ADDENDUM NO. 1 FINAL CD DRAWINGS

Project: Johnson Brock Public Schools

Project No.: L13386

Date: January 31, 2014

K9 SECTION DETAIL 3B
SCALE: 1 1/2" = 1'-0"

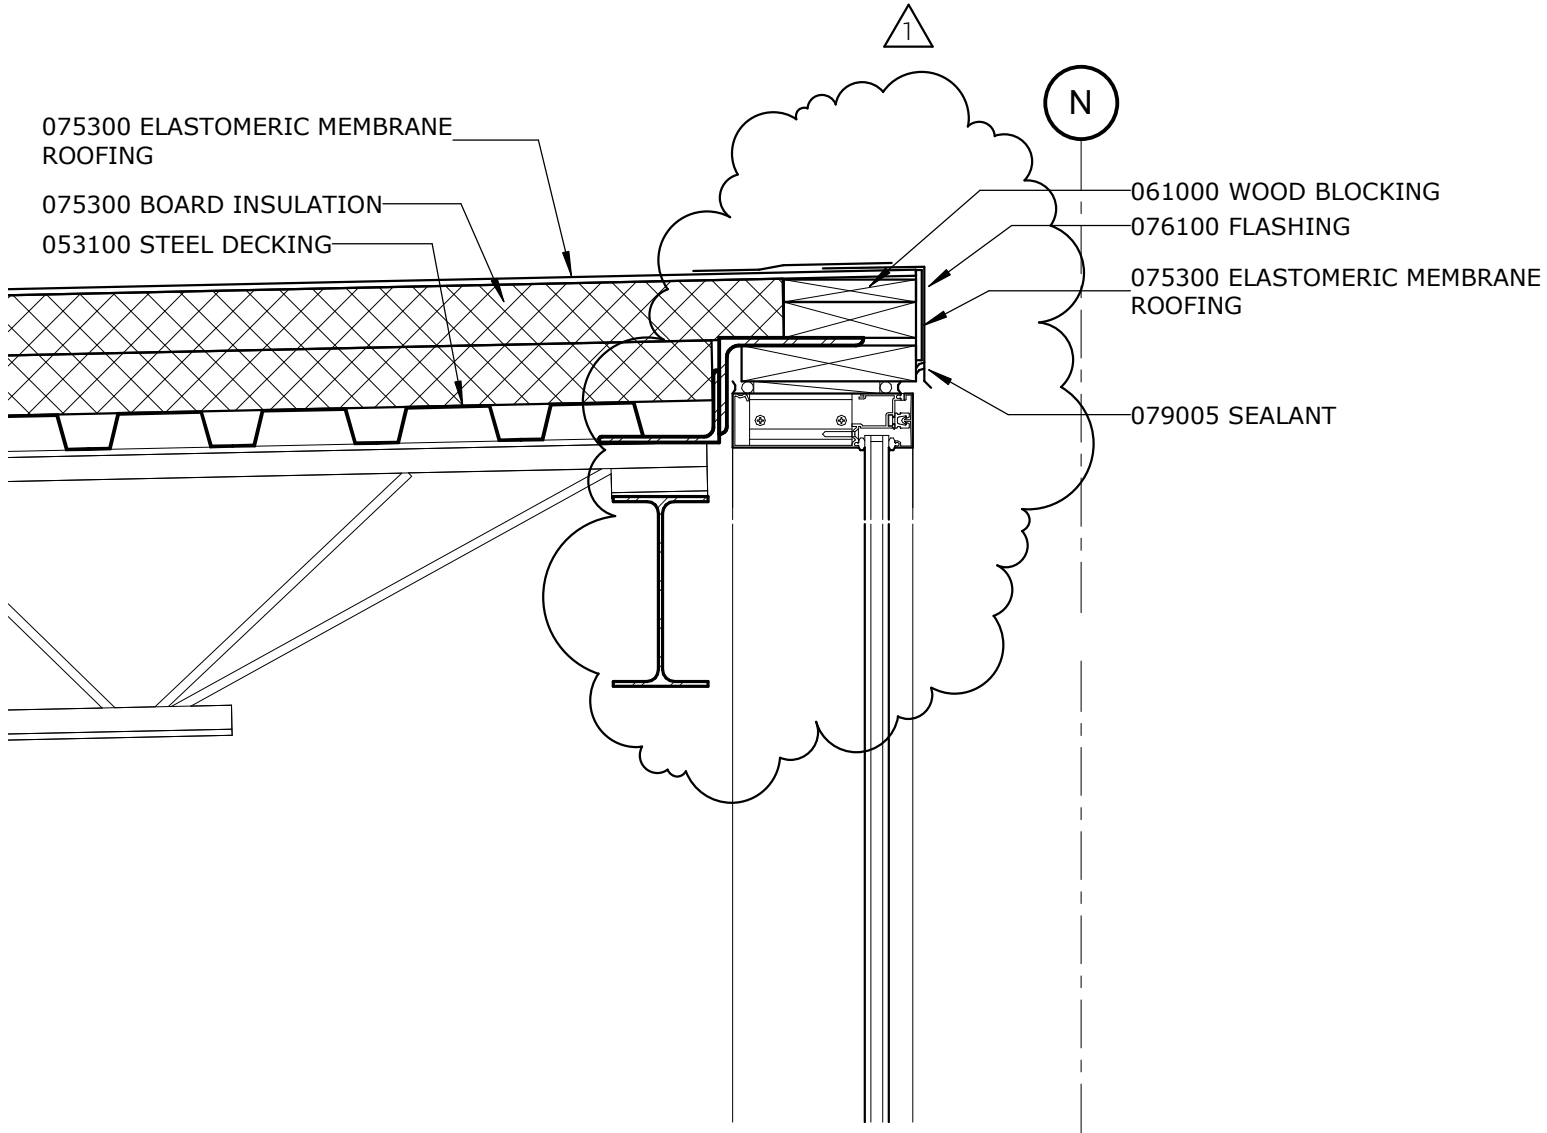
1. See attached "A" for revised detail K9 at stair angle detail.

P9 SECTION DETAIL 3C

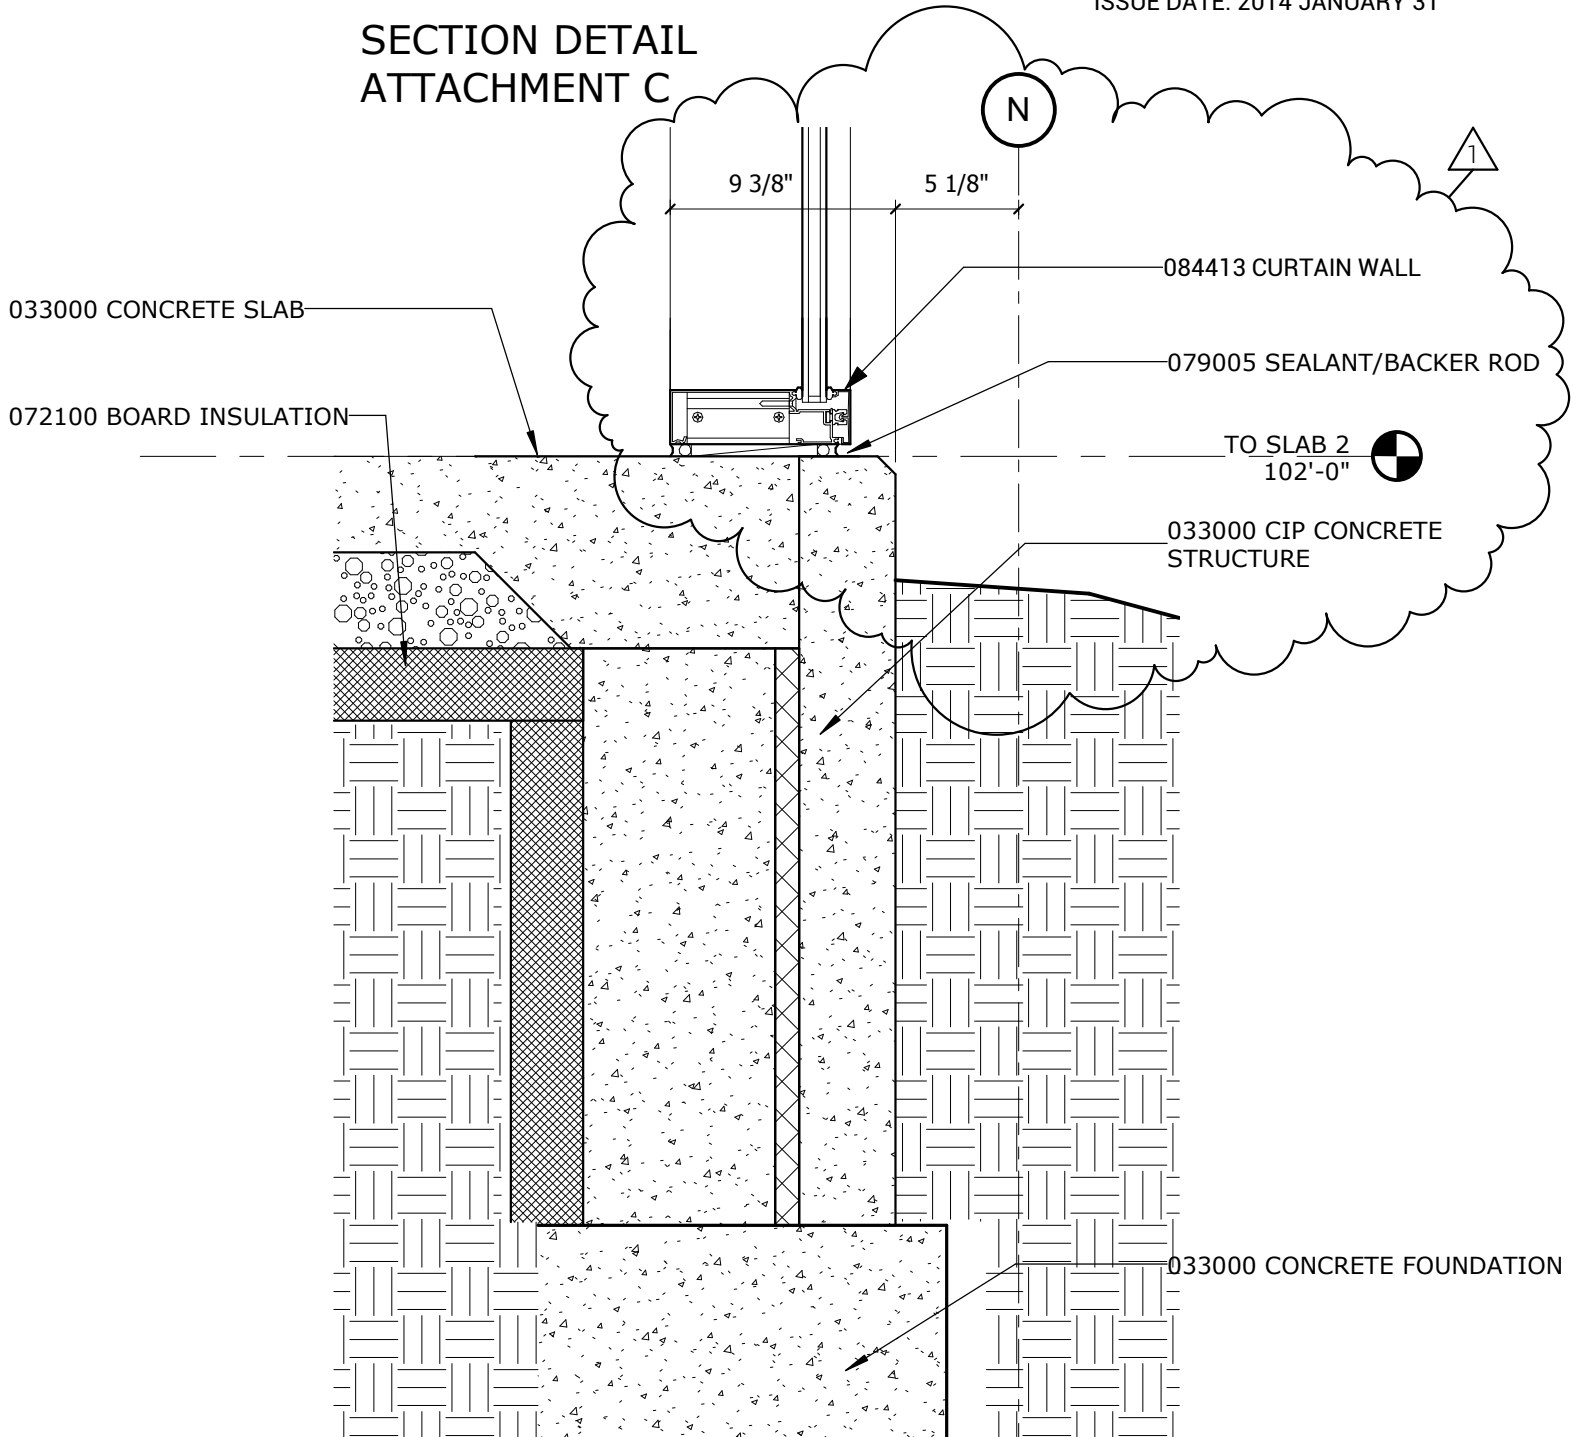
1. Revise curtain wall glass location to exterior – see attached details A, B, C, and D.

A7.1R

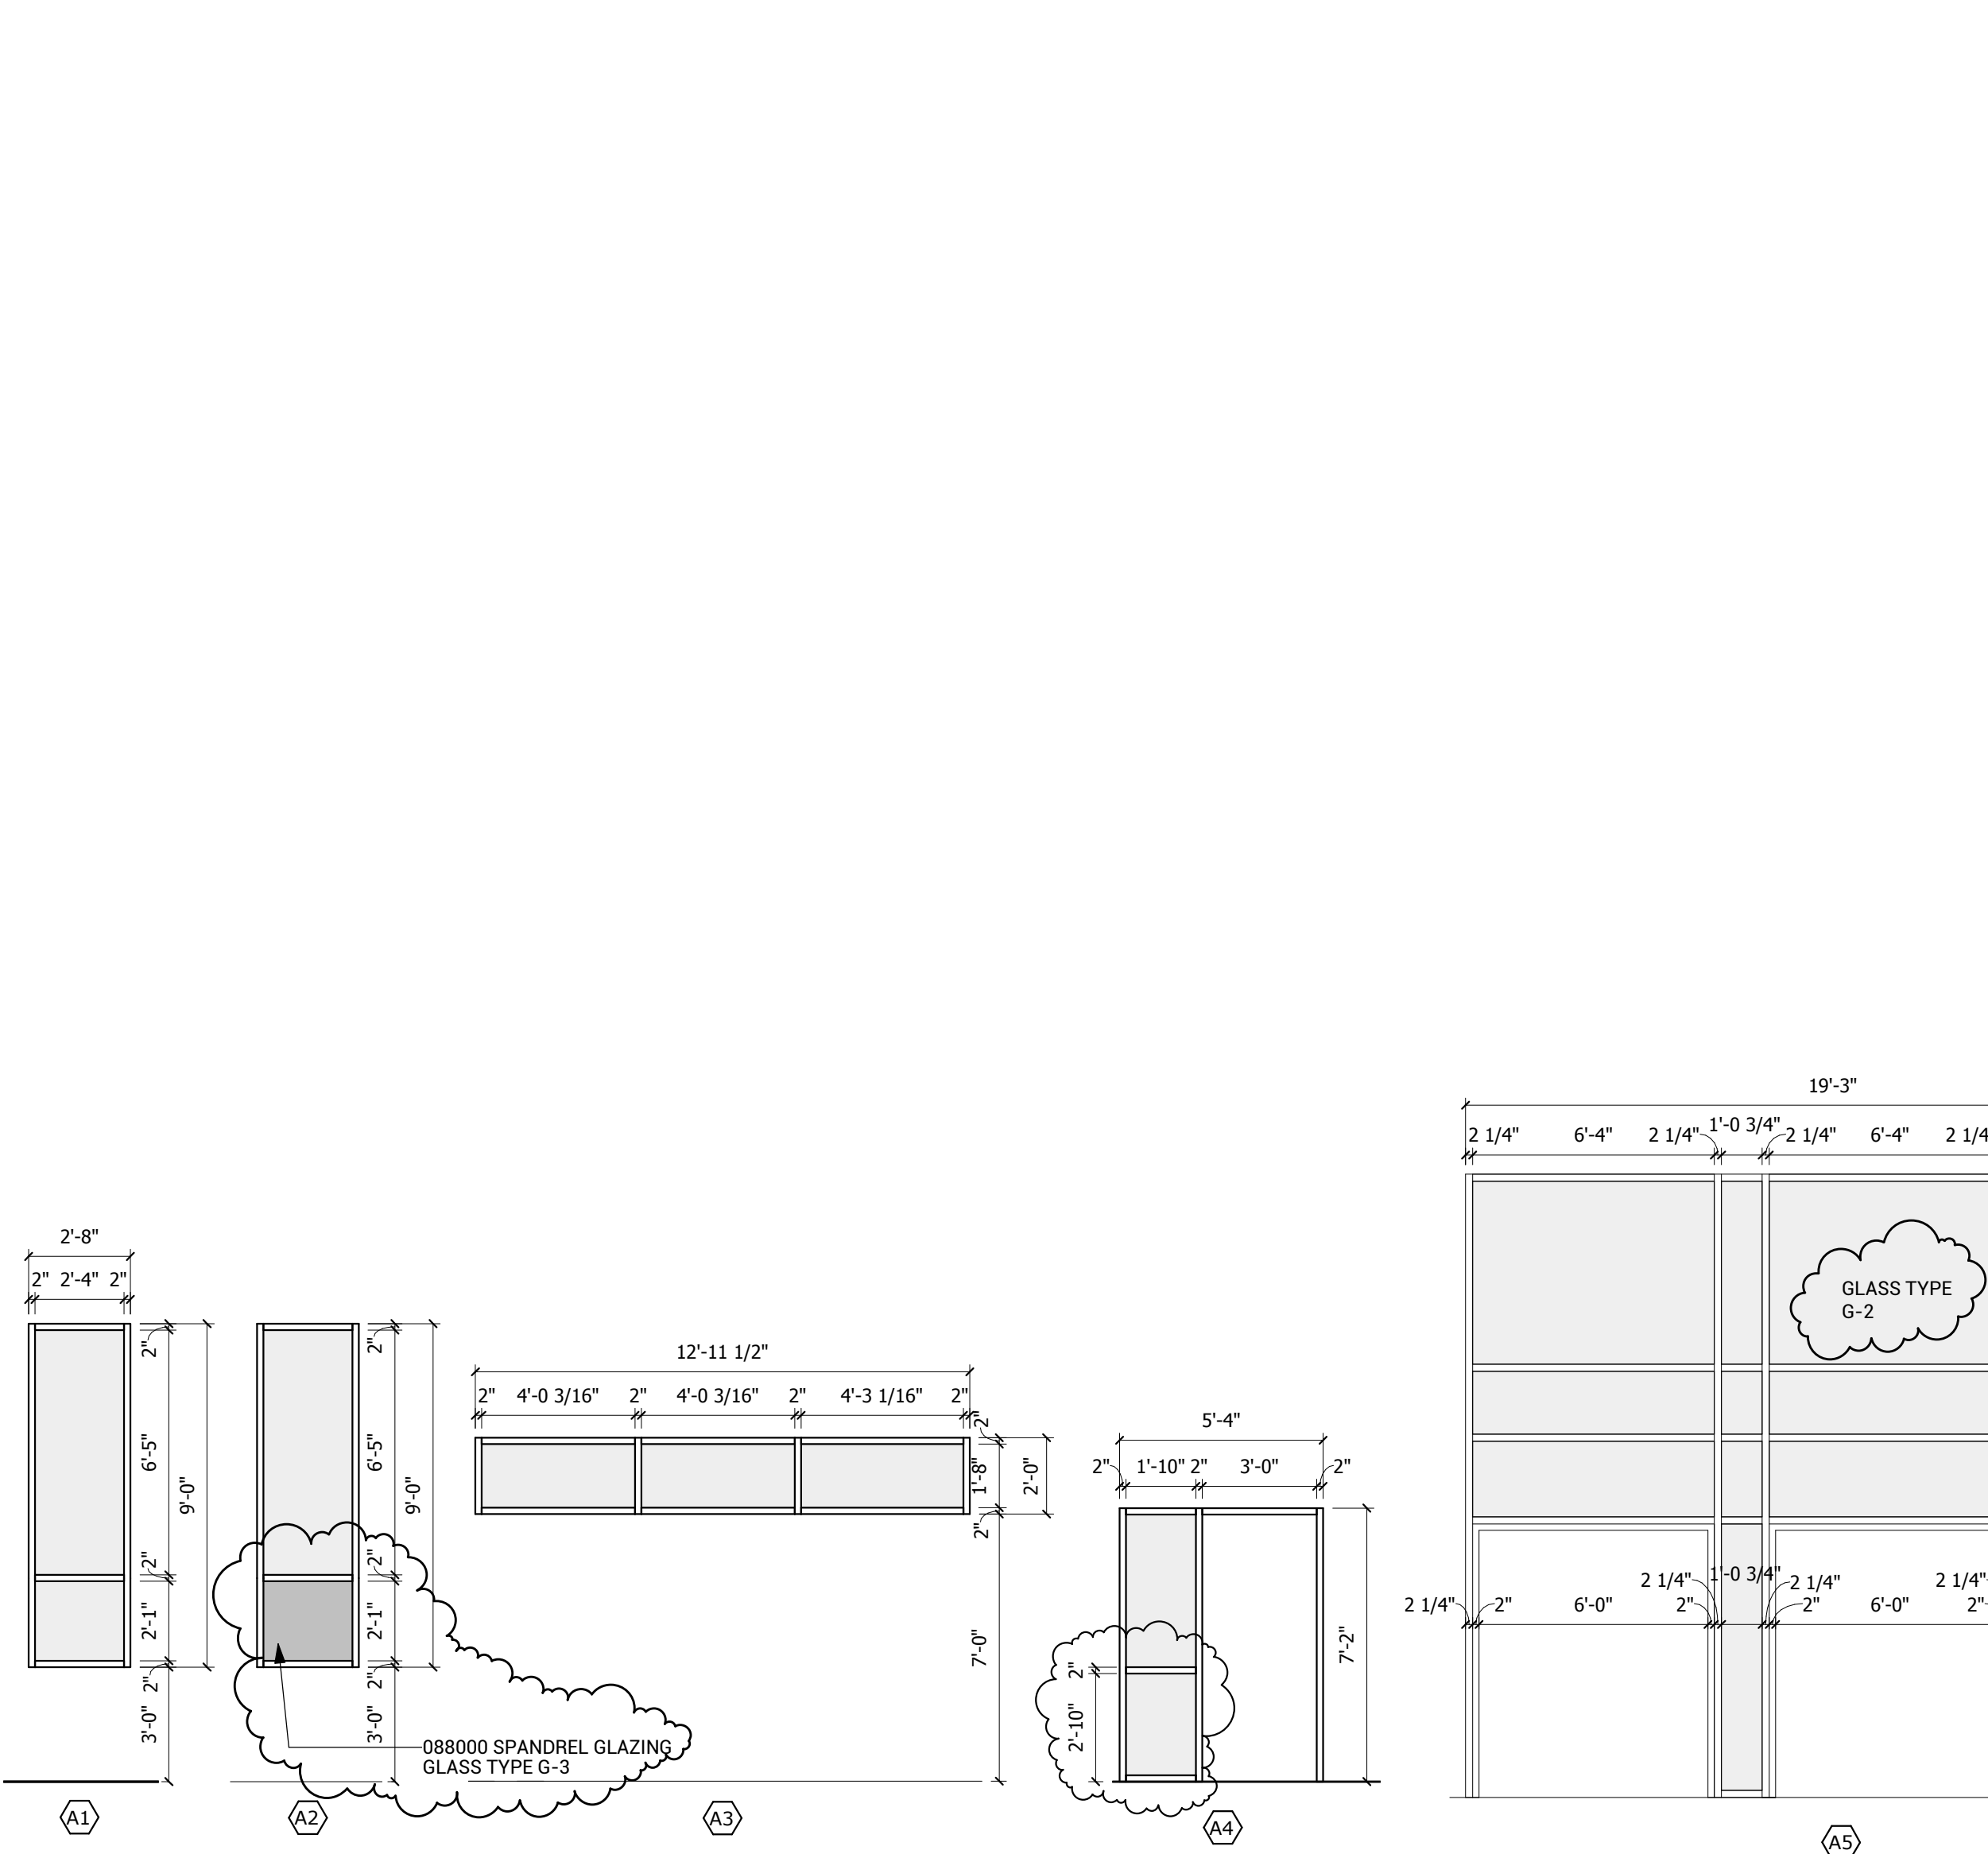
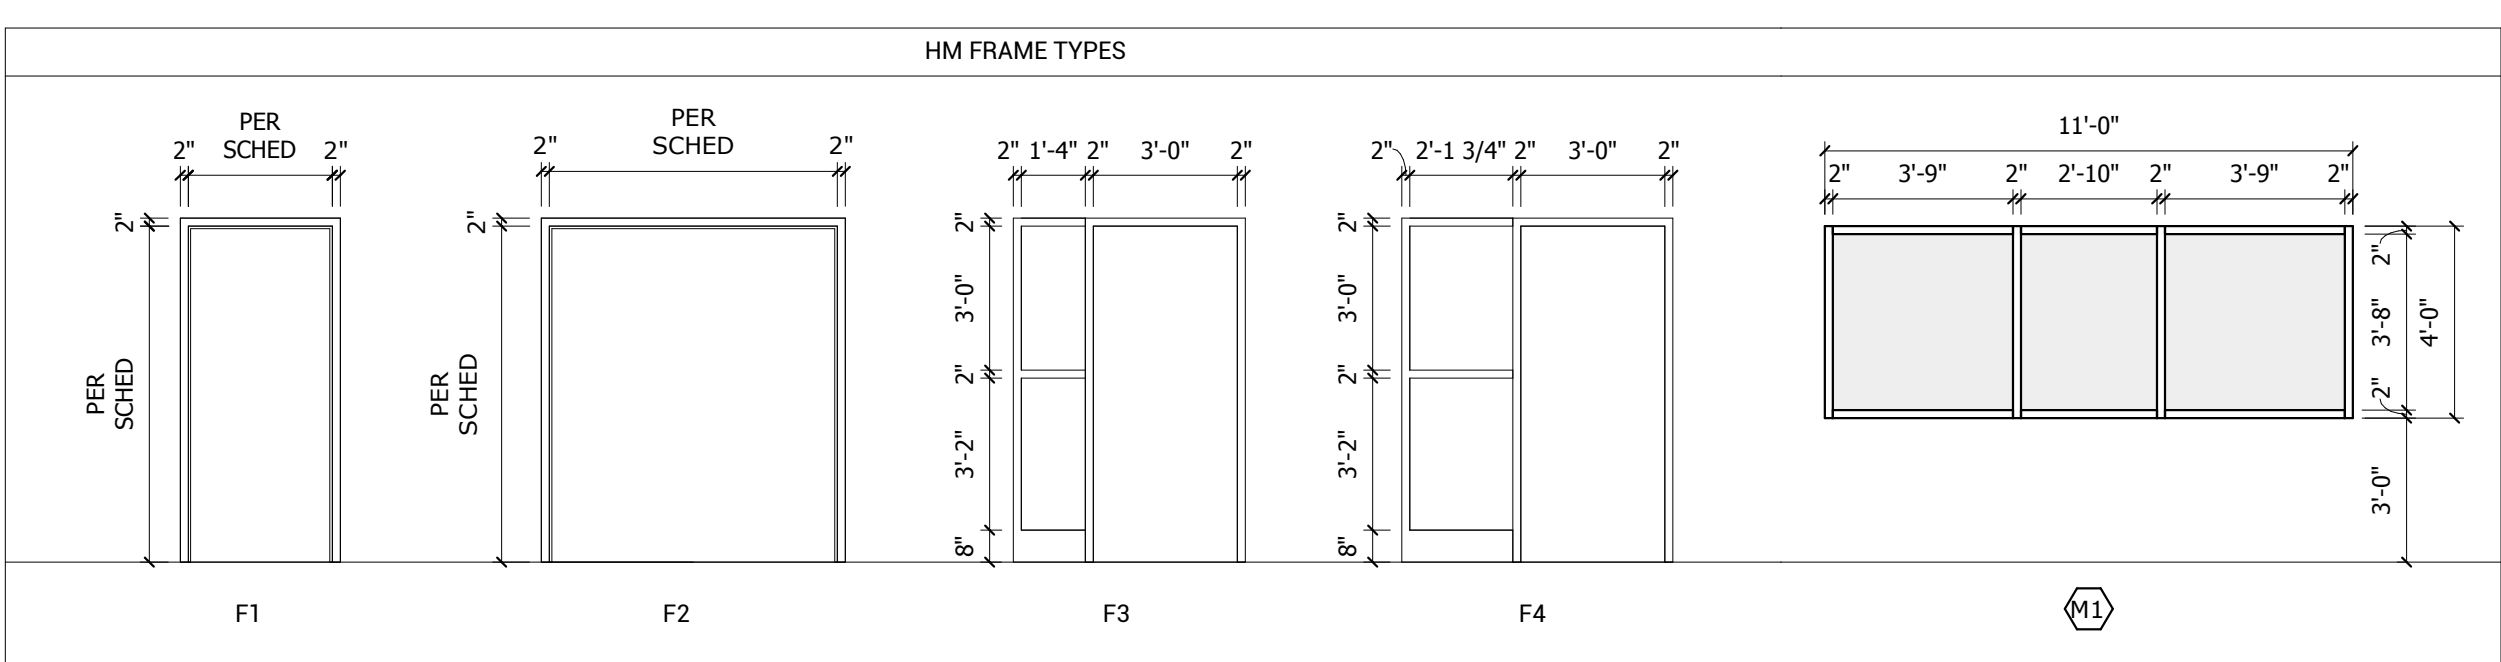
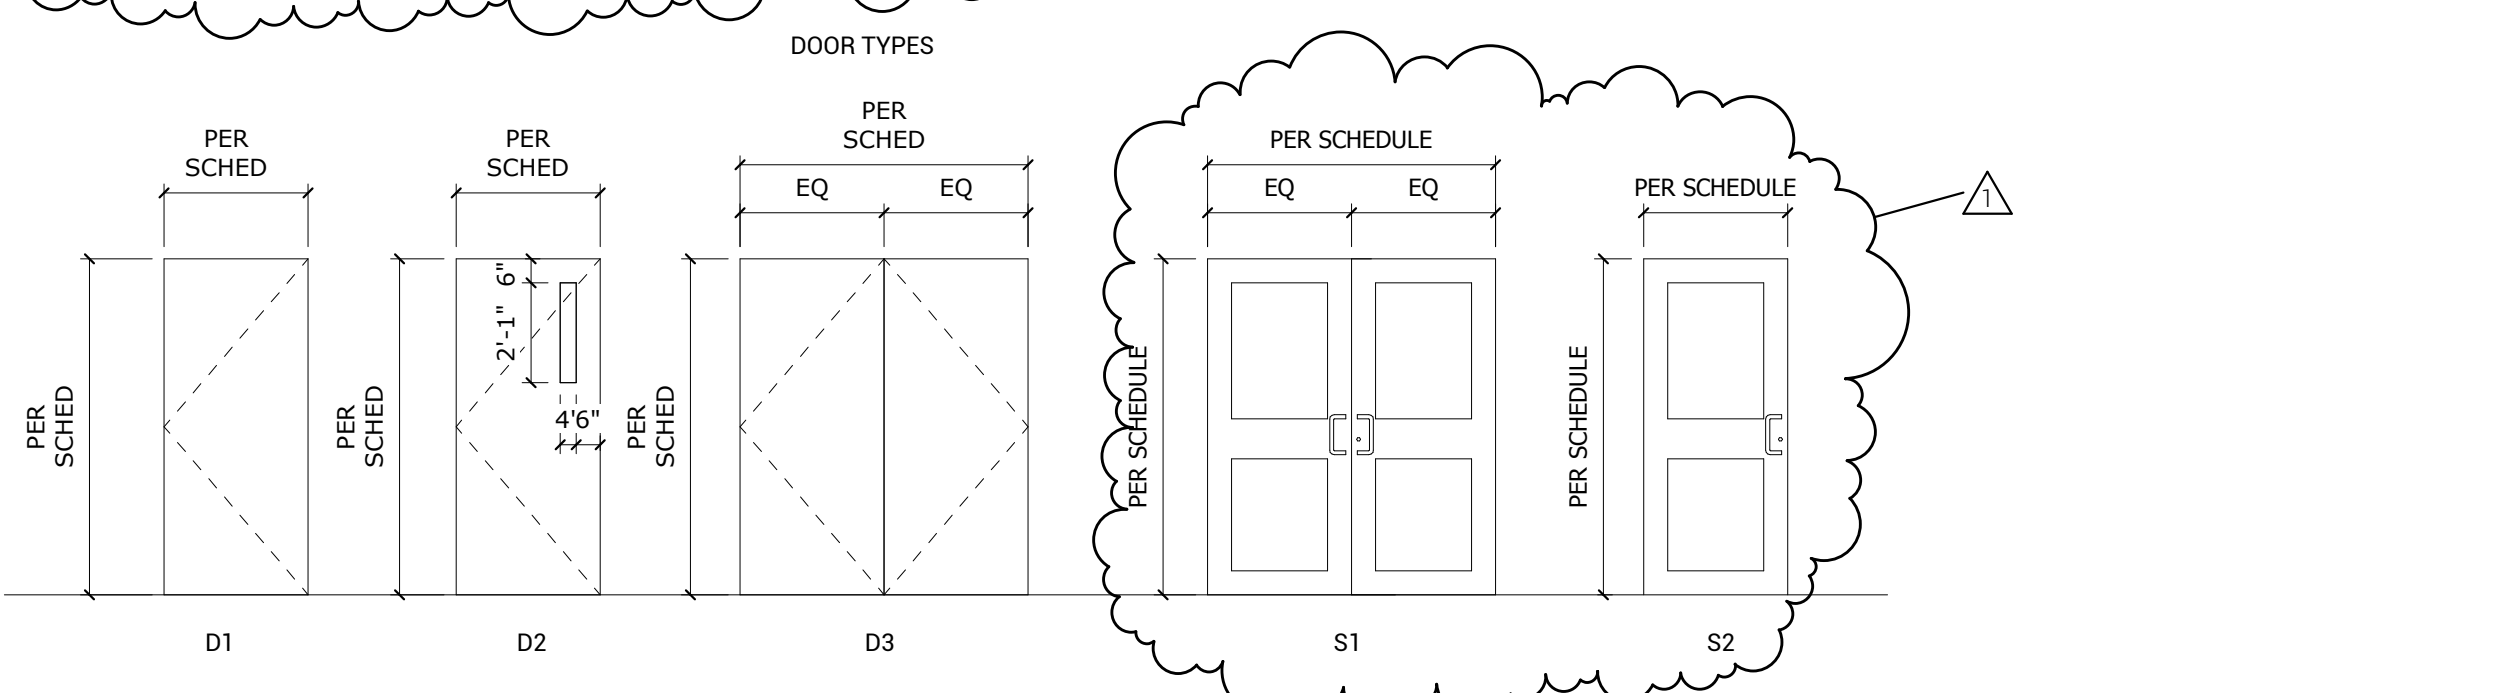
1. Attached A7.1 replaces previously in its entirety.
